**ZONING BOARD OF ADJUSTMENT
TOWN OF HANOVER, NH**

**APPEAL OF AN
ADMINISTRATIVE DECISION**

RE: 34 Greensboro Rd, Appeal of Administrative Decision

Wetland Boundary Plan
Christ Redeemer Properties
Greensboro Rd. Hanover, NH
August 26, 2025

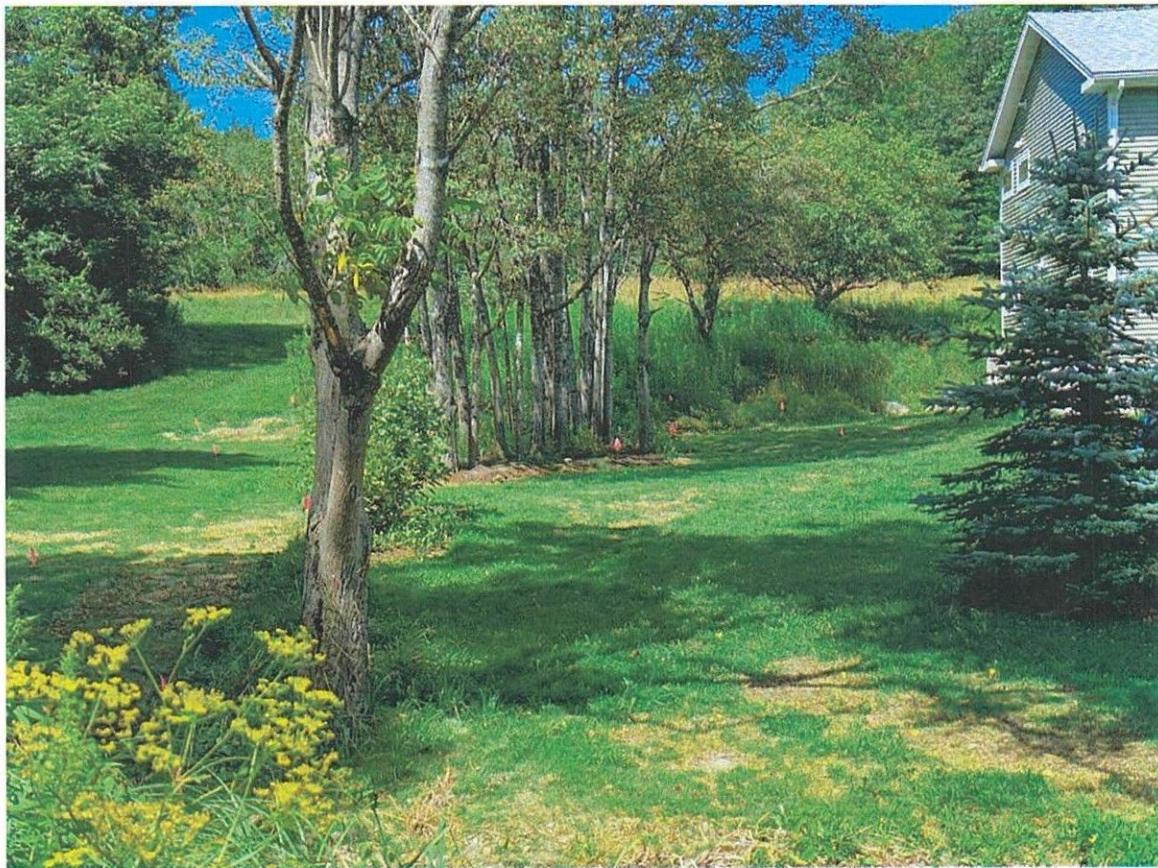
*email from Bruce Simpson, Town of Hanover Zoning Administrator on 6/26/25 @ 2:54pm said he notified Chris Audino, CRC Pastor to stop work and get dredge & fill permit

4. July 7-Work restarted despite the fact that CRC had not been granted a permit, the Contractor was once again asked by the ZA to stop the work and get the appropriate permit. The contractor continued the work anyway and in fact that day removed native soils and vegetation and brought in new soil to backfill over the French drain.

(Note different colored soil in trench and all native vegetation disturbed)

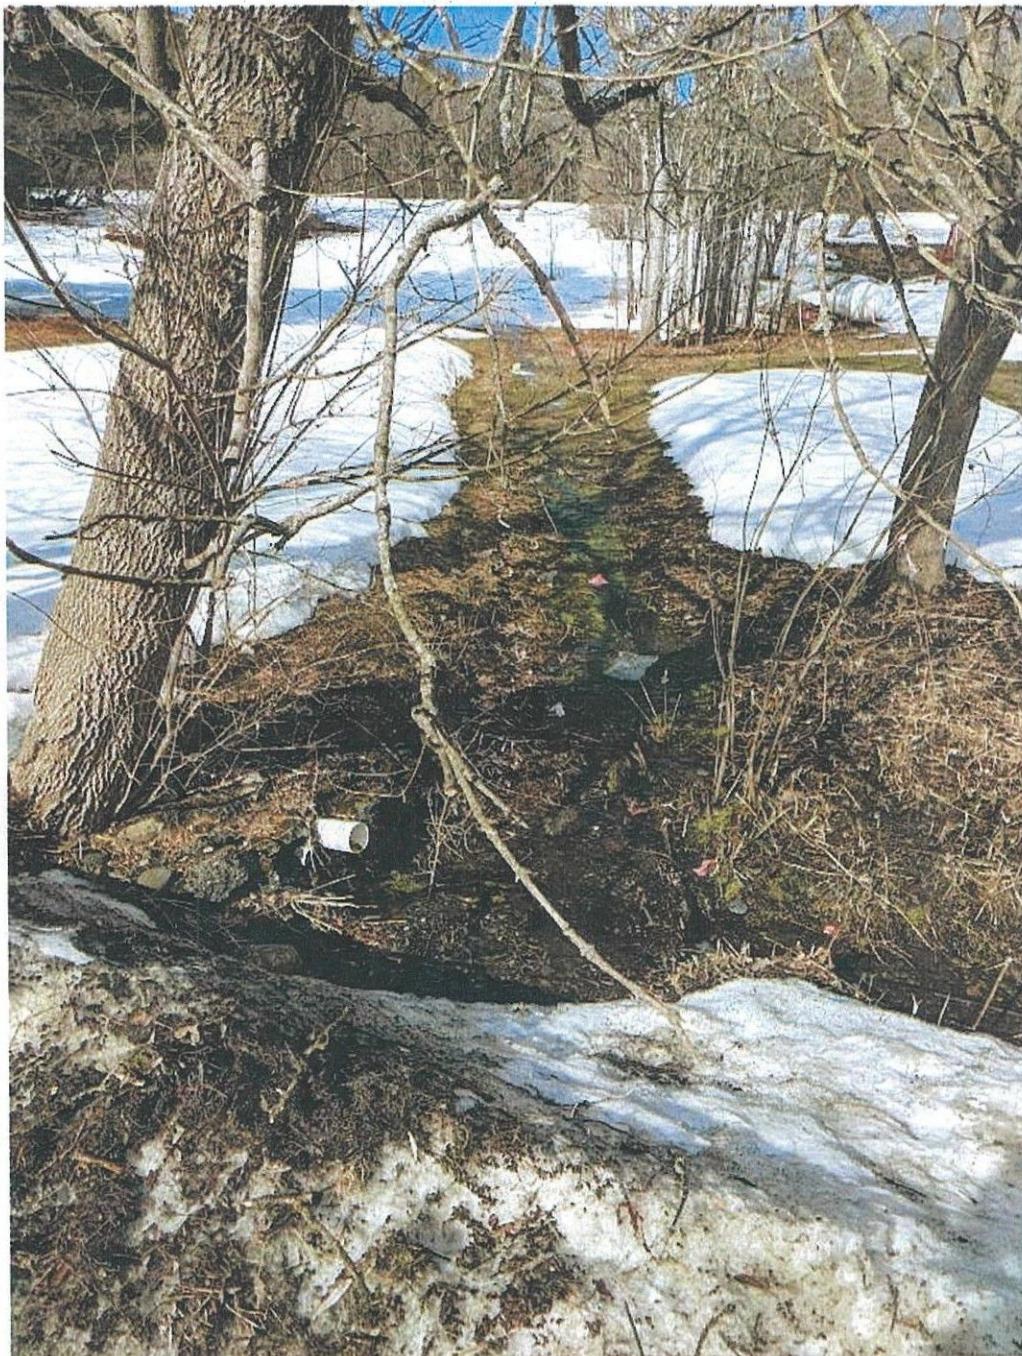
This picture was taken from Greensboro Rd in November. Water is very clearly visible running from North to

Another picture from Greensboro Rd., this one taken in late March. Note again the water running between the two areas. Also note that the vegetation in the wetland is already turning green while the lawn areas are the two areas. Also note that the vegetation in the wetland is already turning green while the lawn areas are

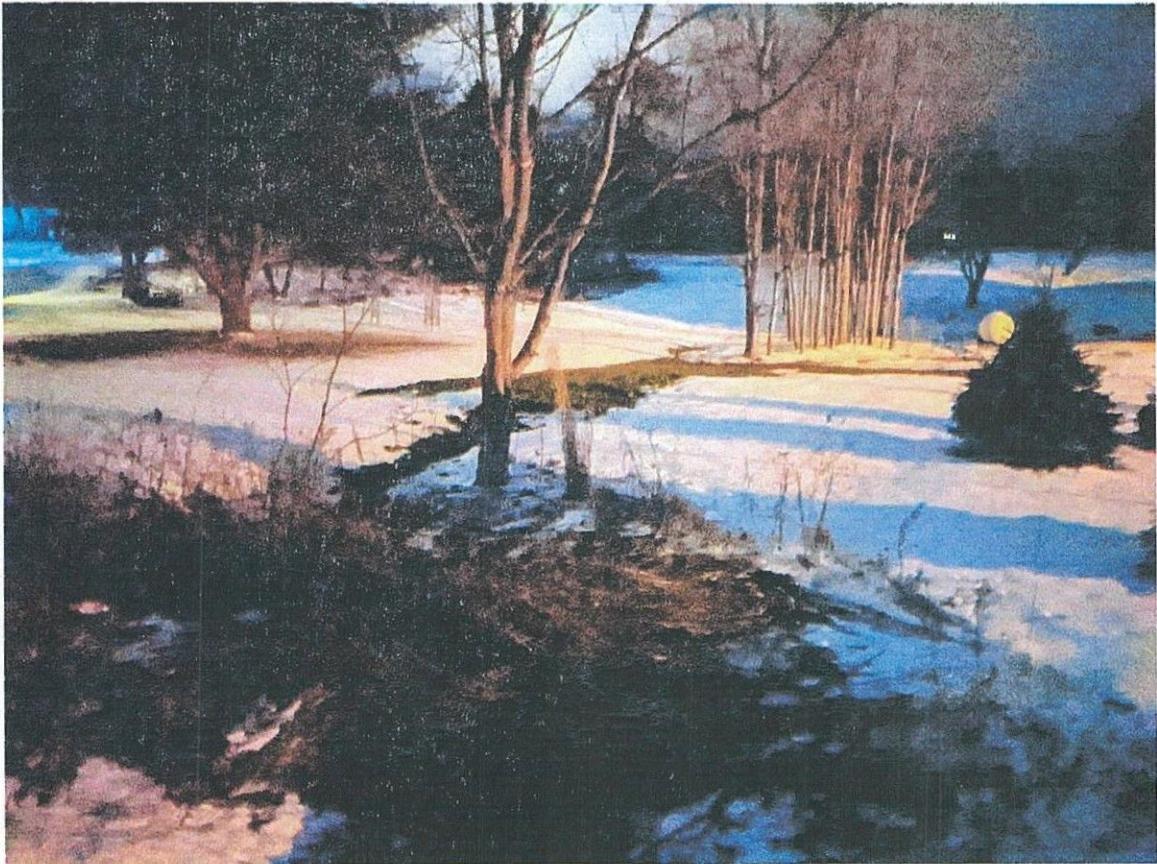
This picture was taken in July 2019 after one of CRC's many attempts to dry the wetland. You can see that there is flowing water in the hand dug trench. Note that the lawn has not been mowed because it is too wet for a mower. Note also the fresh bark mulch that CRC spread under the trees in an effort to soak up water.
